CLIENT	ZANCOR HOMES
PROJECT/LOCATION	KING CITY KING CITY, ONTARIO
DRAWING	SITE GRADING PLAN

BUILDING STATISTICS	REG. PLAN NO.	65M-4295
ZONE	R4	
LOT NUMBER	3	
LOT AREA(m) ²	N/A	
BLDG AREA(m) ²	N/A	
LOT COVERAGE(%)	N/A	
No. OF STOREYS	2	
MEAN HEIGHT(m)	8.33	
PEAK HEIGHT(m)	N/A	
DECK LINE(m)	N/A

REVIEWED AS NOTED

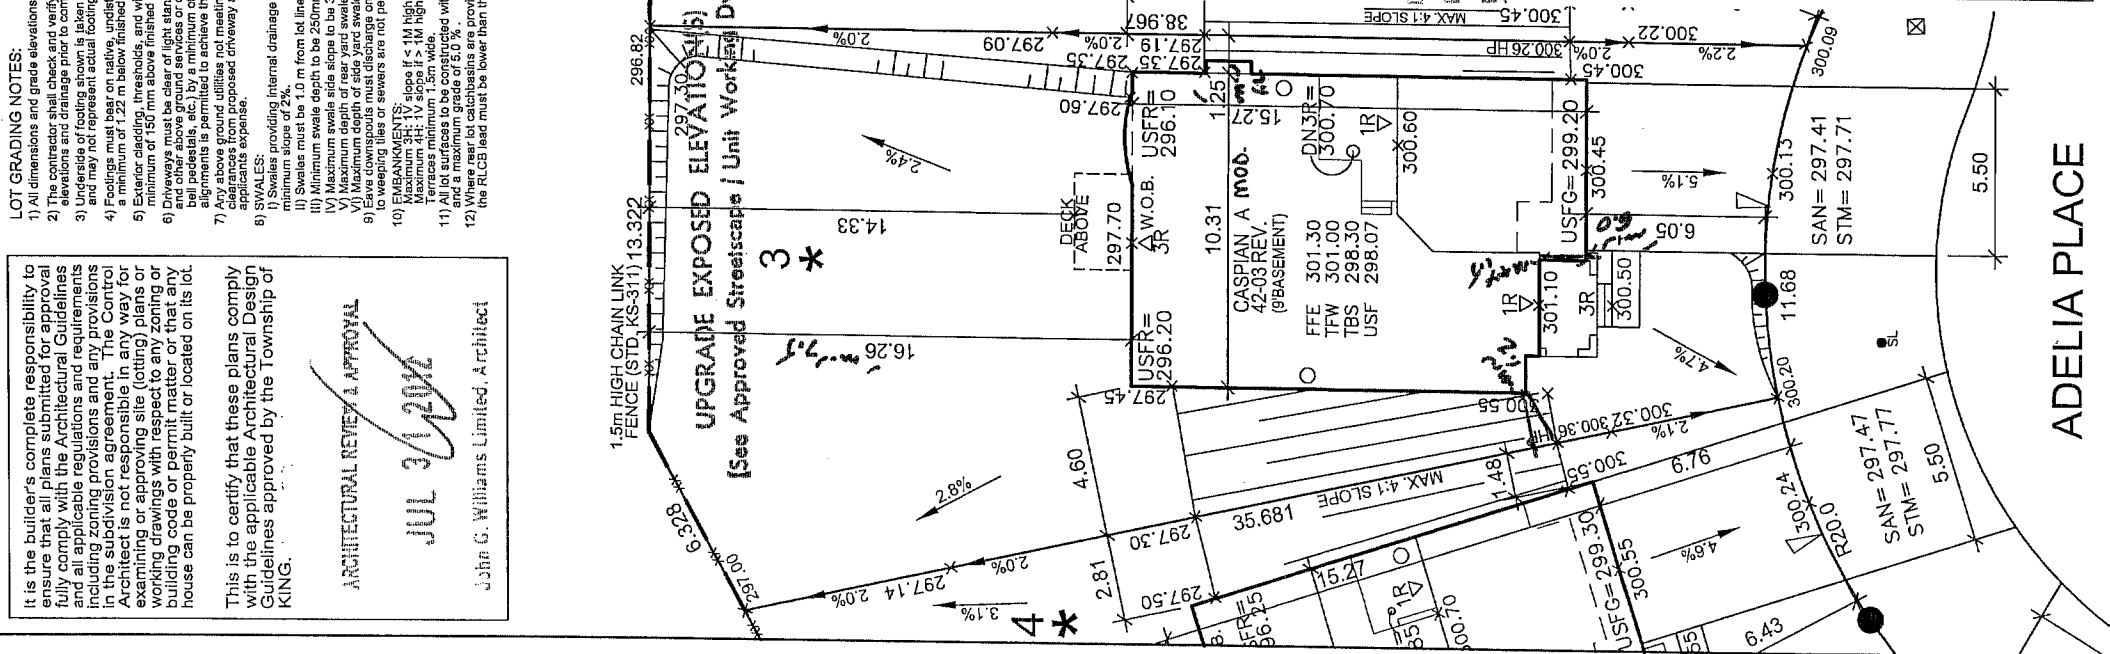
☒ Reviewed as noted

- NOTES:
- Builder to verify storm and sanitary service lateral elevations prior to pouring footings
 - Extend footings at front to ensure 1.25M cover (Min)
 - Garage footings to extend to original ground or as directed by soils engineer.
